Access Compliance Report

Public Rights-of-Way

(Curb Ramps)

Intersection ID: 10005	Main Street: ROSLYN_AV	Cross Street: S_GARDNER_AV	Location:	N
ADA ID: 81C2E013D45B	Ramp Type: BlendTrans2	Initial Pass/Fail: Fail	Overall Compliance: No	Severity Score: 10
Codes/Mitigation Info/Possible Solution		Field Measurements/Component Compliance

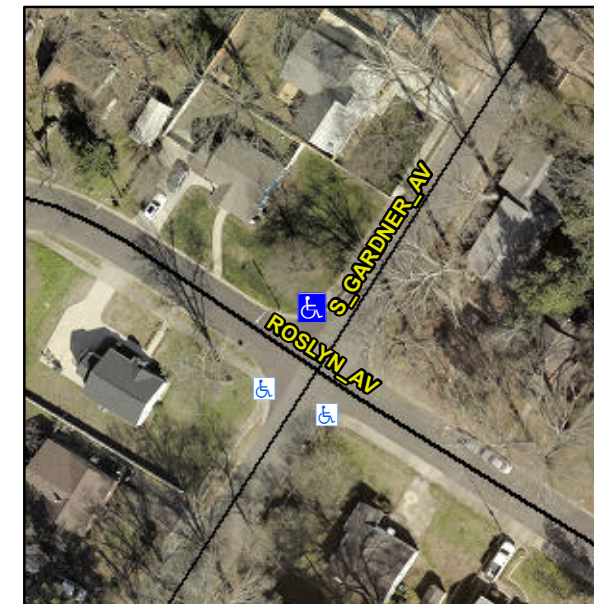
NO RT SW

Not Found, R304.5.1, R304.5.3

Compliance	Description	Data	Compliance	Description	Data
N/A	Ramp Length (in)	84.0	Yes	BlendTrans Slope (%)	2.4
No	Ramp Width (in)	46.0	No	BlendTrans XSlope (%)	4.4
N/A	Flare Type LT	N/A	N/A	Flare Type RT	N/A
N/A	Flare Slope LT (%)	N/A	N/A	Flare Slope RT (%)	N/A
N/A	Flare Traversable LT?	N/A	N/A	Flare Traversable RT?	N/A
N/A	Landing Length (in)	N/A	N/A	DWS Provided?	N/A
N/A	Landing Width (in)	N/A	N/A	DWS Contrast?	N/A
N/A	Landing Slope (%)	N/A	N/A	DWS Length (in)	N/A
N/A	Landing X Slope (%)	N/A	N/A	DWS Full Width?	N/A
N/A	Landing Curb? (Y/N)	N/A	N/A	DWS Offset (in)	N/A
N/A	Shared Landing?	N/A			
N/A	Gutter Ponding?	N/A	N/A	Gutter Slope (%)	N/A
N/A	Gutter Lip Ht (in)	0.5	N/A	Gutter X Slope (%)	N/A
N/A	Painted X Walk1?	No	N/A	Painted X Walk2?	N/A
	X Walk 1 Direction	To SW		X Walk 2 Direction	N/A
	X Walk 1 Width (in)	N/A		X Walk 2 Width (in)	N/A
	X Walk 1 Slope (%)	0.5		X Walk 2 Slope (%)	N/A
	X Walk 1 X Slope (%)	3.5		X Walk 2 X Slope (%)	N/A

N/A	Ramp inside XWalk1?	N/A	N/A	Ramp inside XWalk2?	N/A
	Road Slope (%)	3.5		Clear Space?	N/A
	Road X Slope (%)	0.5	N/A	Clear Space to XWalk (in)	N/A
N/A	Any Obstructions?	N/A	N/A	Storm Grate/Utility Hazard?	N/A
	Obstruction Type			Storm Grate/Utility Type	
		N/A			N/A
			Yes	Surface Condition? (G/P)	Good
			No	Curb Slope (%)	15.5

Remove & Replace Curb Ramp With Two New Directional Ramps or Equivalent.
